Product Change Notification: CAAN-10DTK0161

CCB 7215 Initial Notice: Qualification of MMT as an additional assembly site for PIC32CX5109BZ31048-V/ZWX and PIC32CX5109BZ31048T-V/ZWX catalog part numbers (CPN) available in 48L VQFN (6x6x0.9mm) wettable flank packages.

PCN Type: Manufacturing Change

ASCL

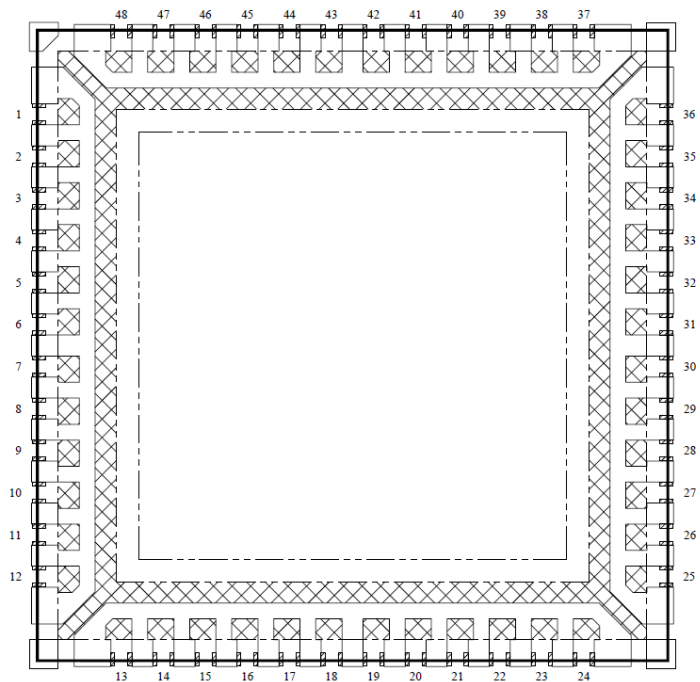
Wire Material	CuPdAu
Lead Frame Material	C194
Lead-Frame Paddle Size	173x173 mils

MMT

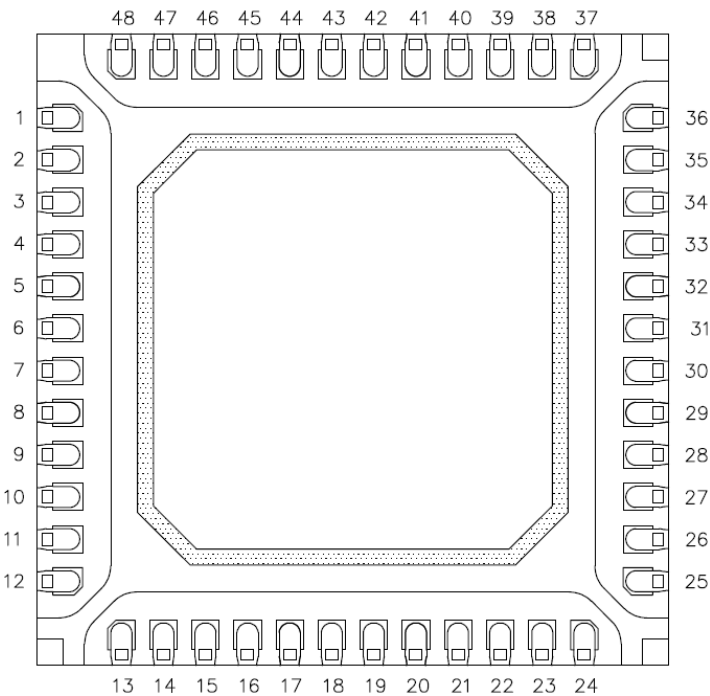
Wire Material	CuPdAu
Lead Frame Material	C194
Lead-Frame Paddle Size	181x181 mils
